Comment #241: BER margin of COM 3dB

Yasuo Hidaka
Fujitsu Laboratories of America, Inc.

Comment #241

CI 110 SC 110.10.7

BER (J1) vs COM (DER0=1E-12)

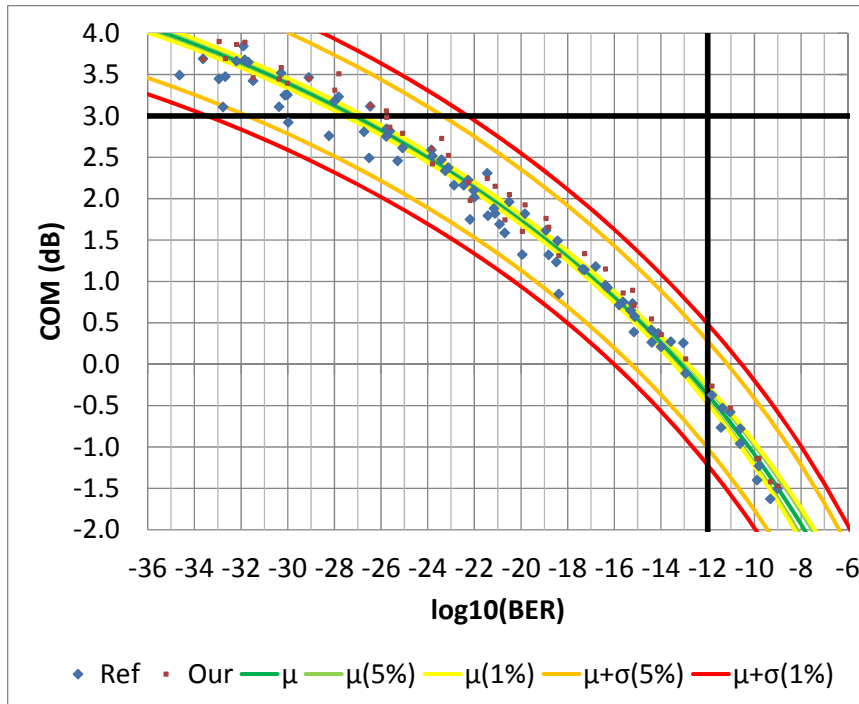
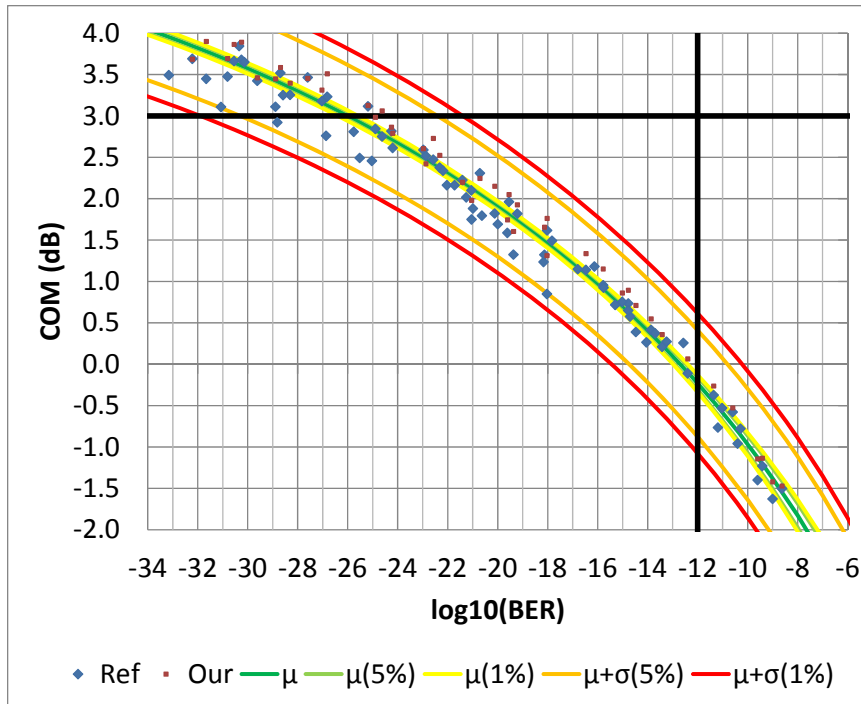
■ Mean COM for BER=1E-12 is -0.365dB (expected value)

- If COM and BER are consistent, this is supposed to be 0dB
 - The difference is statistically significant; 99% confidence interval is [-0.475, -0.256] dB
- If the inconsistency is resolved, COM for the same BER goes up by ~0.365dB
 - This is regardless of whether COM is fixed or BER is fixed

■ If COM is 3.0dB, worst-case BER is 4.9E-23 (99% confidence limit)

BER (J2) vs COM (DER0=1E-12)

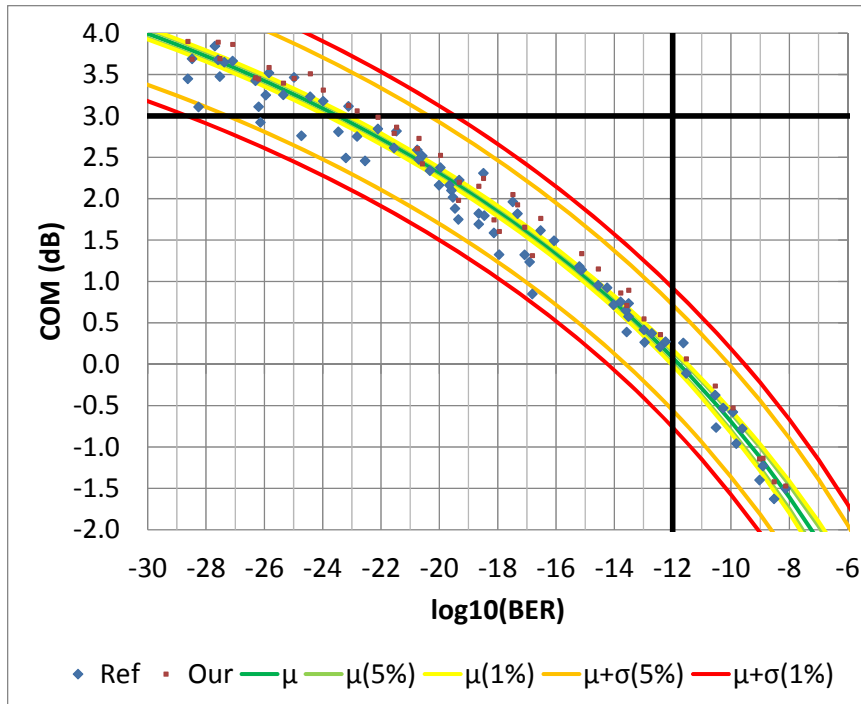
- If COM is 3.0dB, worst-case BER is 3.8E-22 (99% confidence)
 - If COM is 2.5dB, worst-case BER is 9.4E-20, degraded by a factor of 247
- In comparison to J1, BER is a little (one order of magnitude) degraded due to additional jitter of TX EOJ = 0.035U

BER (J3) vs COM (DER0=1E-12)

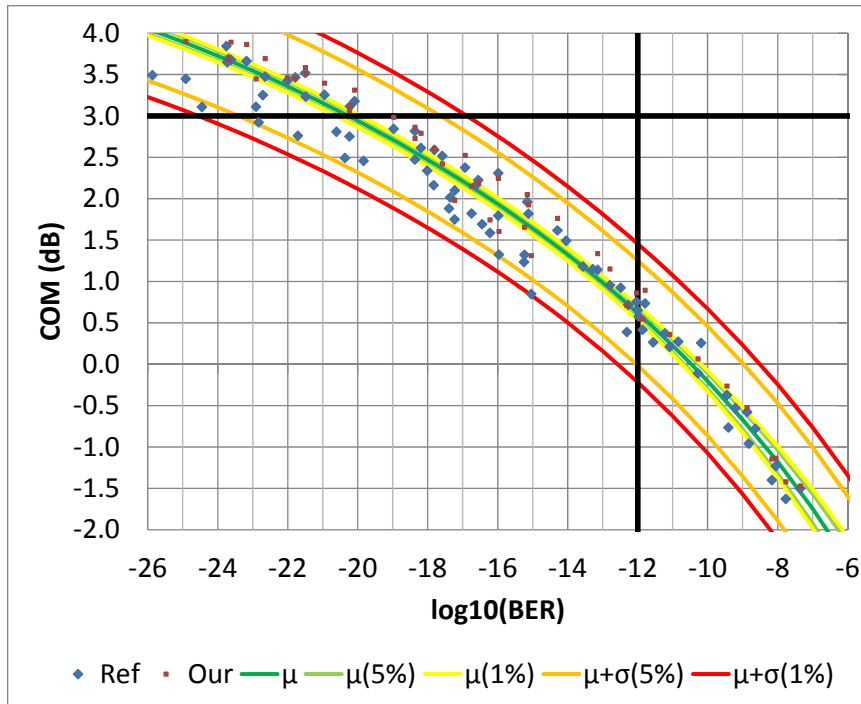
- If COM is 3.0dB, worst-case BER is 3.3E-20 (99% confidence)
 - If COM is 2.5dB, worst-case BER is 4.1E-18, degraded by a factor of 126
 - Typical-case BER is 3.0E-24 (COM 3.0dB) or 1.2E-21 (COM 2.5dB)
- Worst-case BER < 1E-12 (99% confidence) is satisfied if COM > 0.924dB
 - Worst-case BER < 1E-15 (99% confidence) is satisfied if COM > 1.866dB

Relationship between Proposed Changes

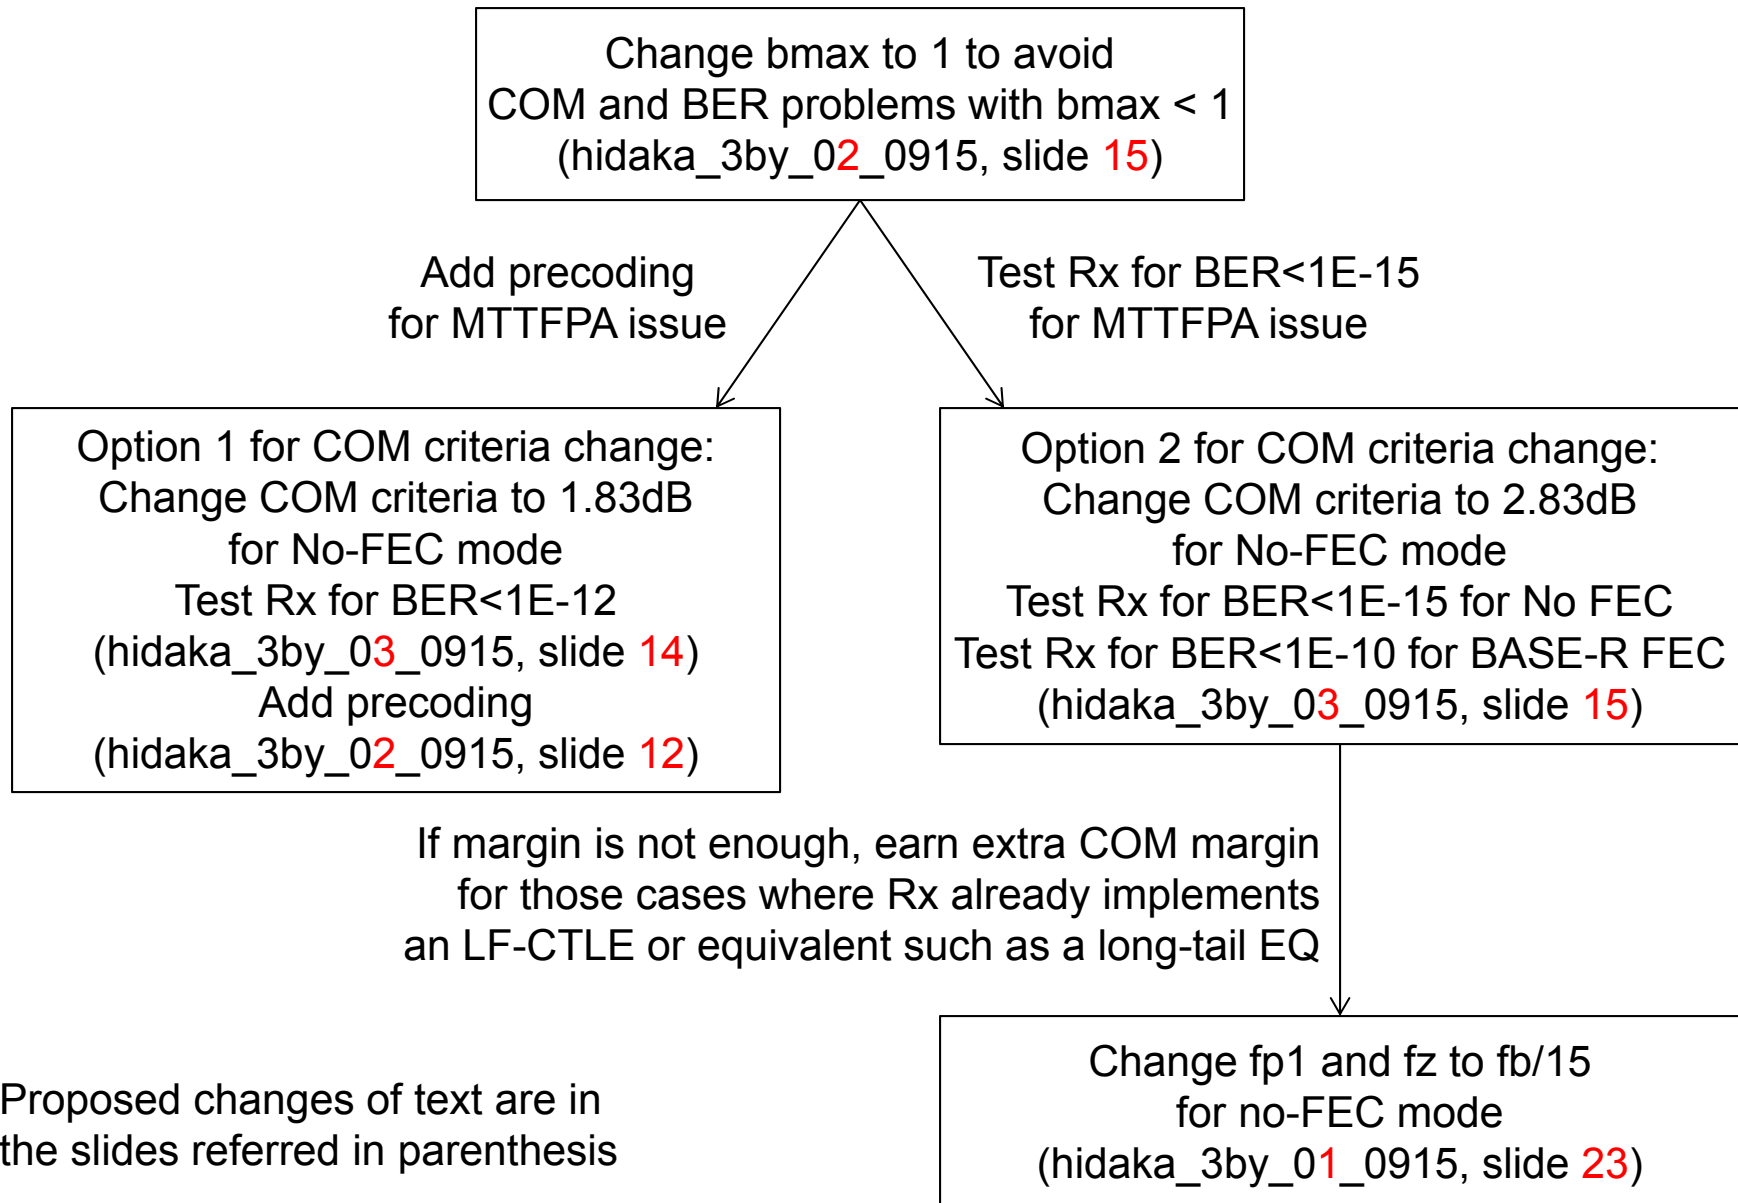
- Revised COM criteria (for no-FEC mode)
 - Option 1 (change of text in slide 14):
 - Change COM 3dB criteria to 1.83dB to guarantee the worst-case BER < 1E-12

- Test Rx for BER < 1E-12 without restriction of DFE coefficients
 - Add precoding to meet the MTTFPA requirement
 - Option 2 (change of text in slide 15):

- Change COM 3dB criteria to 2.83dB to guarantee the worst-case BER < 1E-15
 - Keep DER0 as 1E-12
 - Test Rx for BER < 1E-15 to meet MTTFPA requirement
